RE: Permit Application for the Greenpointe Class  
Two Construction, Demolition, and Land-  
Clearing Debris (C&D) Landfill Expansion  
Permit No.: LF2-00001  
Project No.: 16227-0004

In response to your comments via email on August 14, 2020 for the referenced project, we have the following comment response. The following items were brought to our attention in the aforementioned email and are listed along with our response to each item:

**FOLLOW-UP REVIEW COMMENTS BY STORMWATER SECTION:**

## Pond No. 1 - Detention Basin #1

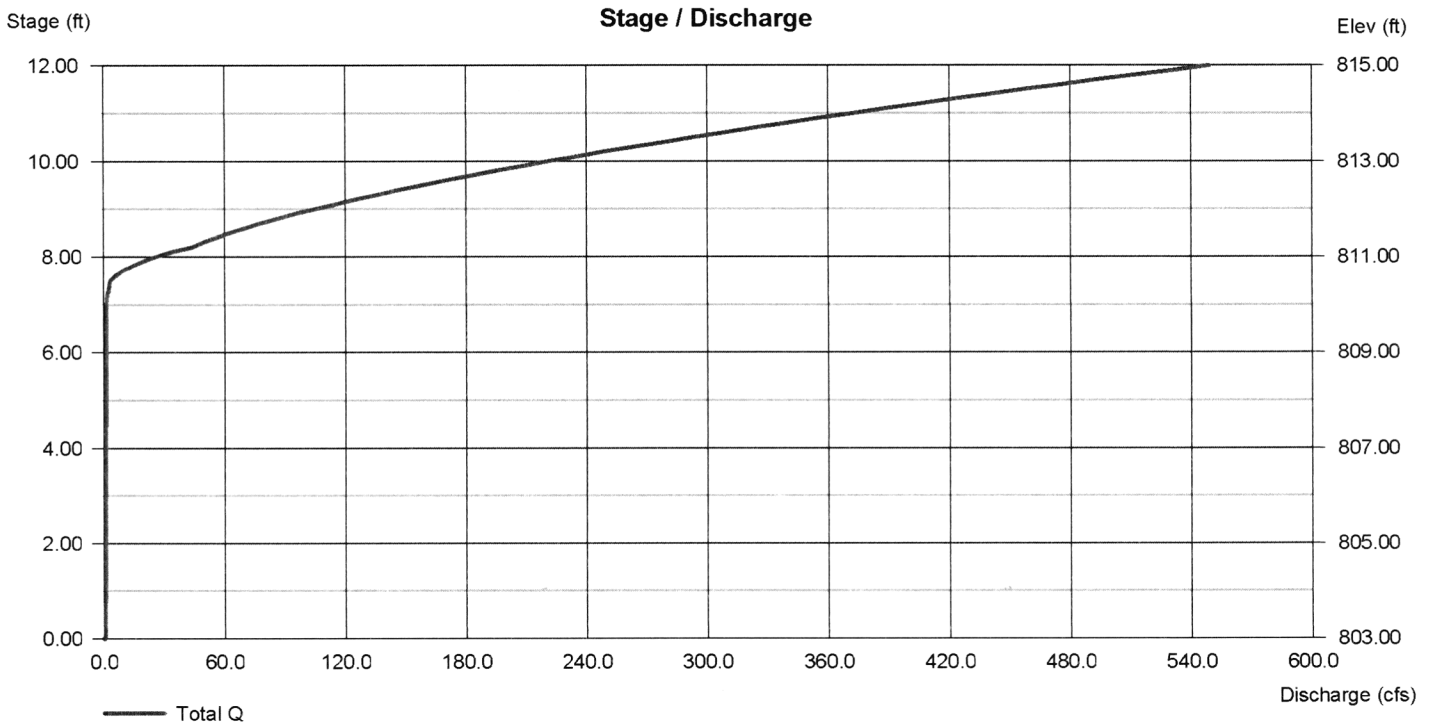
1. *Line item 17 from the review comments response letter still needs to be corrected. Basin 1 lists the riser crest length as 16.5' in the hydrology report, Basin 2 lists 16.0' (which is correct with the drawings which also show 16.0'), and Basin 3 15.0' in the hydrology report. The HydroCad report needs to be updated for Basins 1 and 3 to match the Construction Plans.*

- **The riser crest lengths for Basins 1, 2, & 3 in the Post-Development Hydraflow Report match the Outlet Control Structure Details shown on Sheet C8.1 of the Construction Plans (DWG No. 01,1168-D21 dated August 20, 2020). The Post-Development Hydraflow Report and Sheet C8.1 have been enclosed for your reference.**
